UNITED STATES PATENT AND TRADEMARK OFFICE

APPLICATION NO.	FILING DATE	FIRST NAMED INVENTOR	ATTORNEY DOCKET NO.	CONFIRMATION NO.
10/010,149	11/12/2001	Robert F. Evans	FCI-2580/C2977	7215

Office Action Summary

DETAILED ACTION

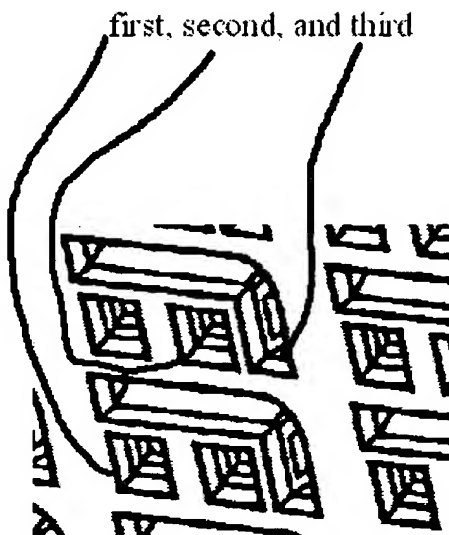
-- In reference to claim 21, Kline shows (cover sheet)

the plurality of receptacle contacts 24 are substantially cylindrical shaped.

-- In reference to claim 23, Kline shows (see examiner's figure) the columns are arranged in repeating patterns of first, second, and third columns and the first and second columns are spaced farther apart than the second and third columns.
